**CITY OF CHESTERFIELD
PLANNING COMMISSION MEETING
MONDAY - APRIL 9, 2007**

Lauren Strutman of Busch-Strutman L.L.C. has submitted an Amended Site Development Plan and one freestanding business sign for your review. The Department of Planning has reviewed these submittals and submits the following report.

Planning Commission Staff Report

PRELIM. DEVELOPMENT PLAN CROSS SECTIONS HUNTLEIGH SECURITIES

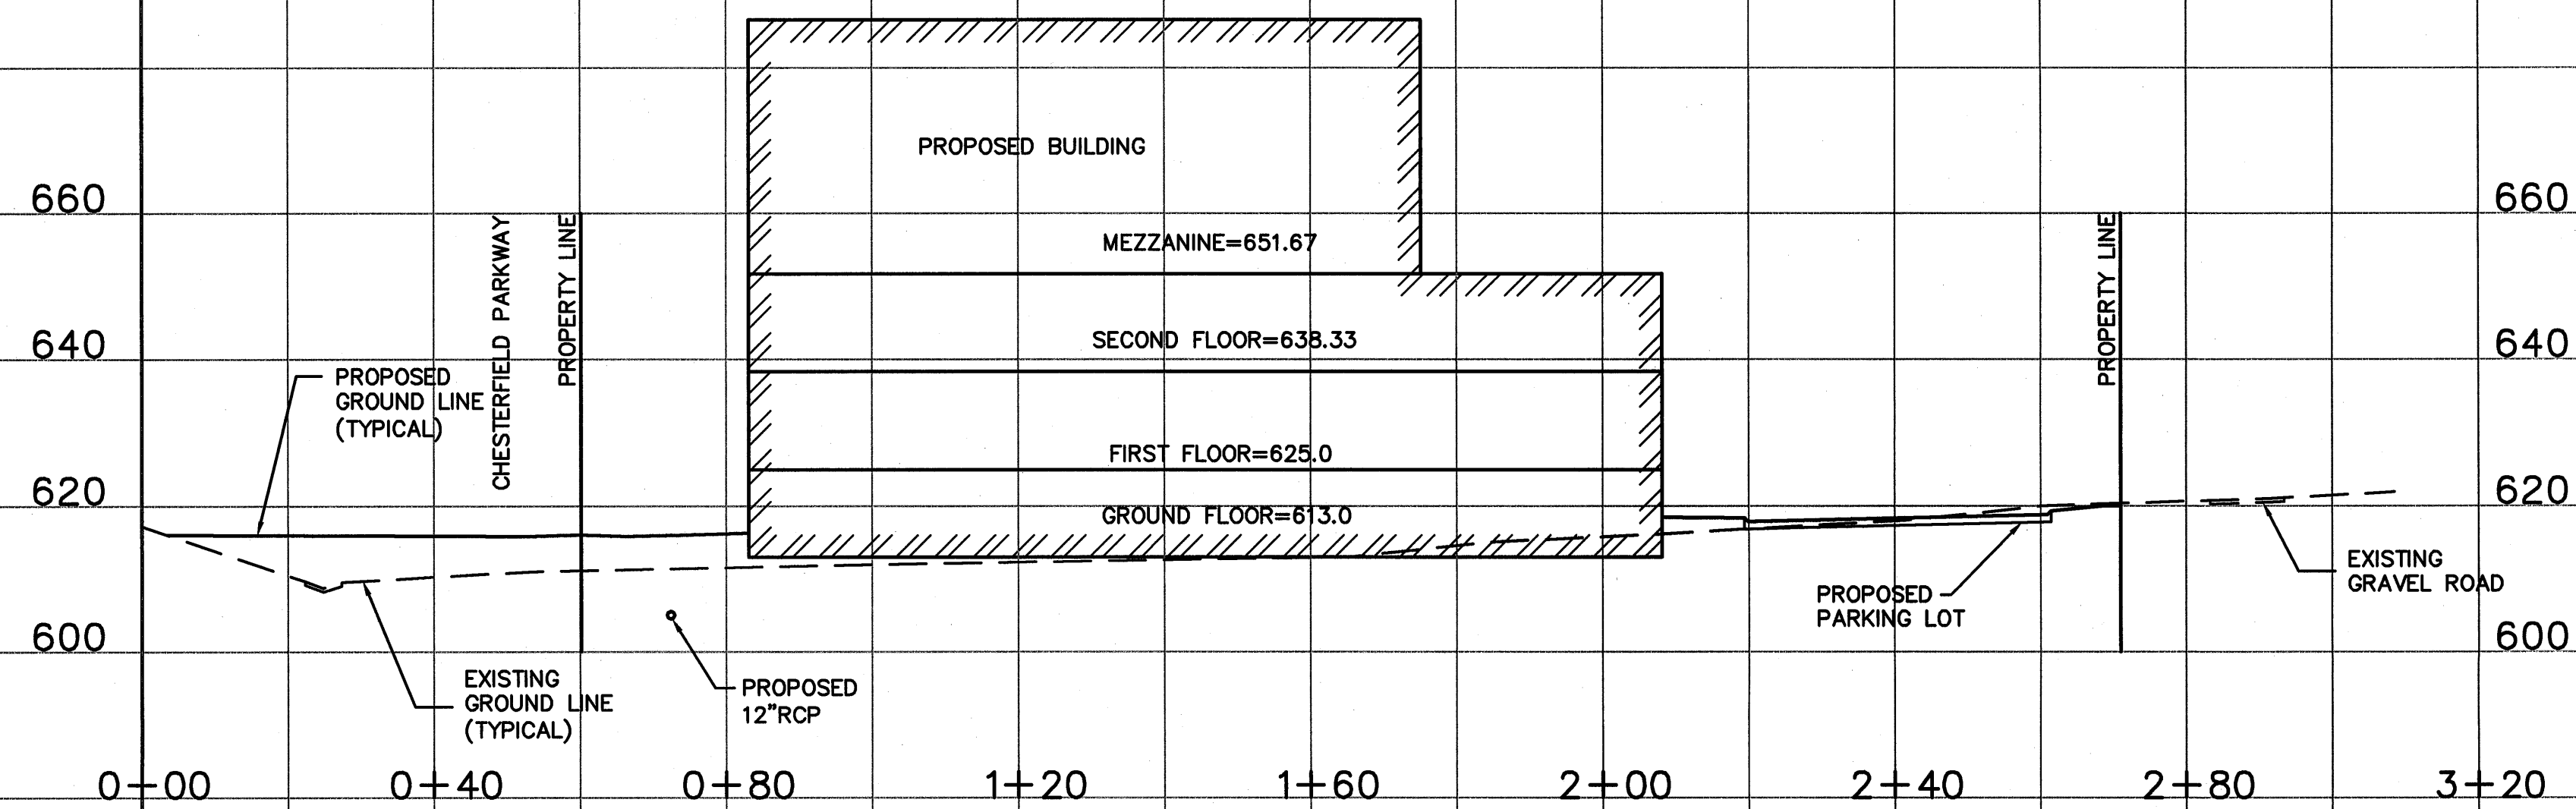
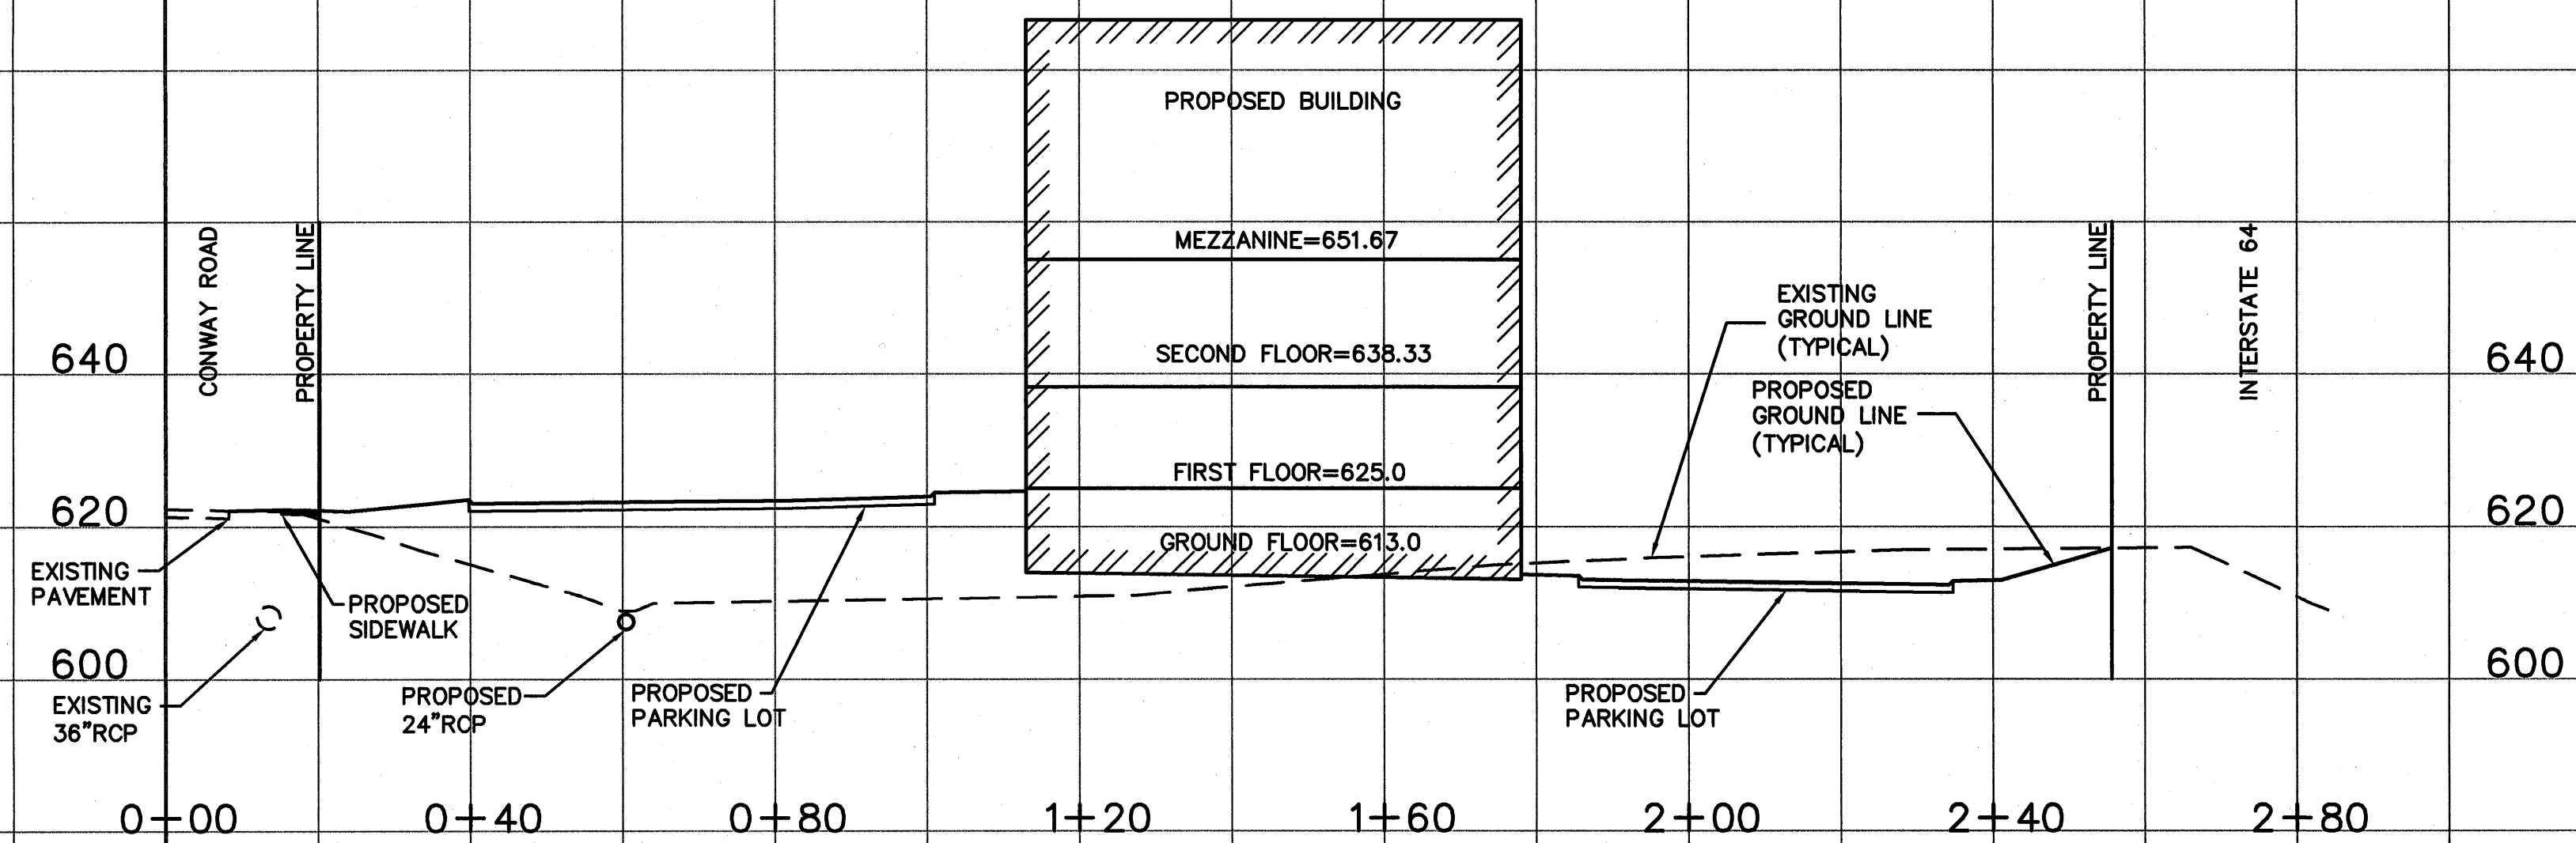
5. On sheet 1 of 3, portions of the sanitary force main appear to be located outside the existing utility easement. Either the force main alignment will require revision or additional easements obtained. This issue need not be addressed at this time, but will be reviewed in greater detail during review of the Improvement Plans.
